**STAFF REPORT: 09-09-2020 MEETING**

**APPLICATION NUMBER: 20-6829**

**ADDRESS: 3333 CAMBRIDGE**

**SCOPE: REAR PORCH ALTERATION**

HDC Staff Photos – Site Visit, 08/29/2020

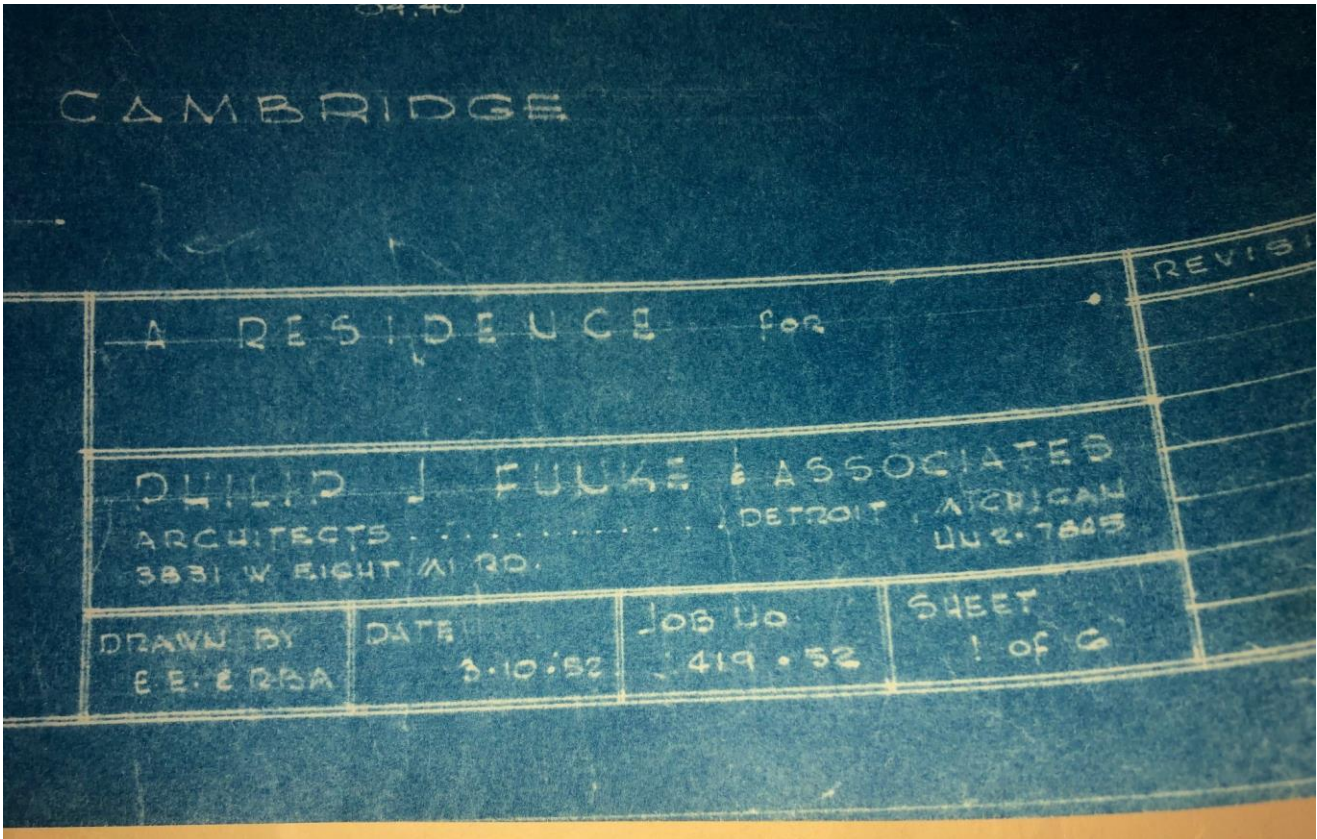
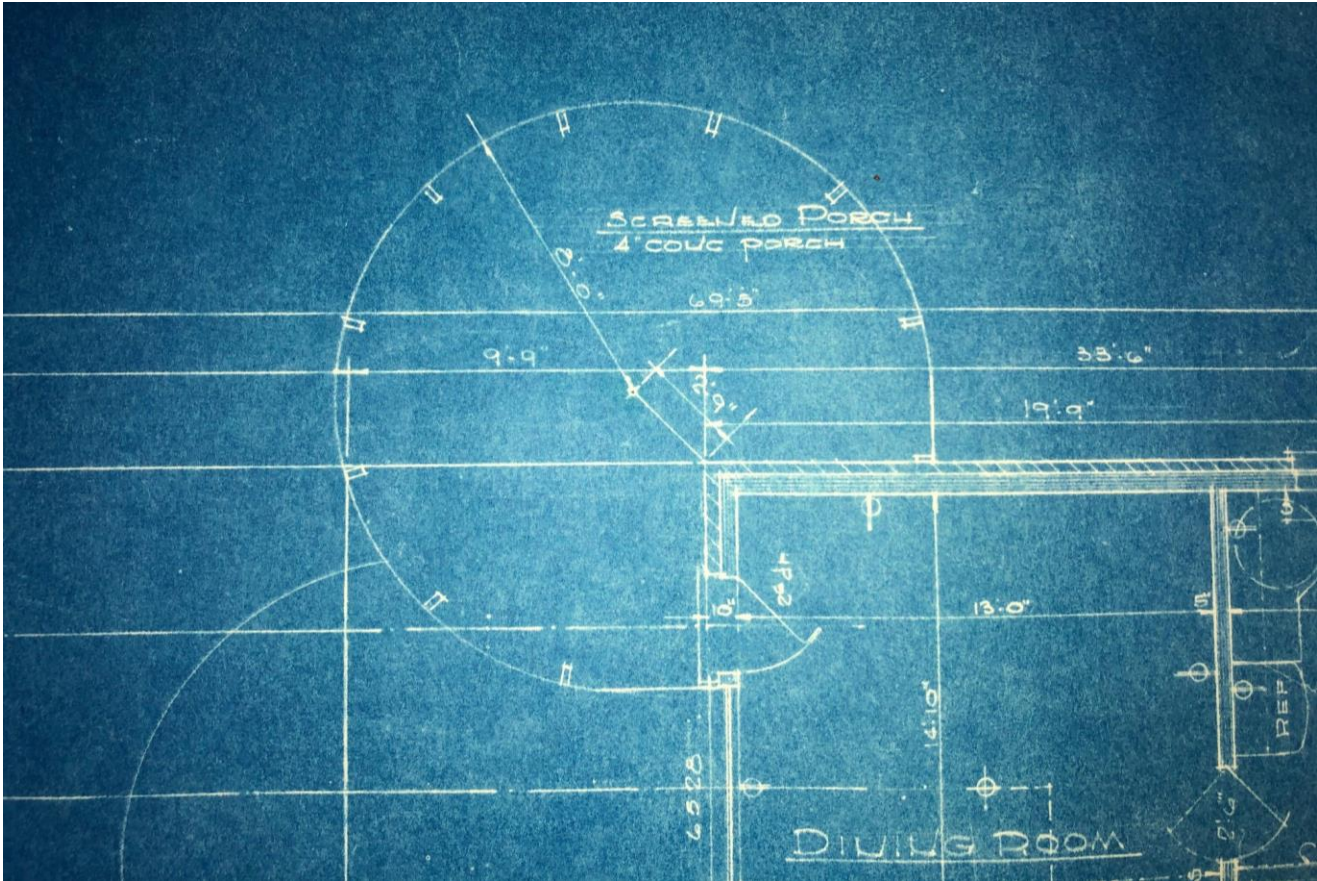
- The existing shrubs are very close to the wood panels. Staff believes accumulation of snow on, and in-between, the shrubs will continue to exacerbate moisture problems with the new panels.
- The scope of work says gutters will be removed, but it doesn't mention they will be reinstalled (with downspouts).
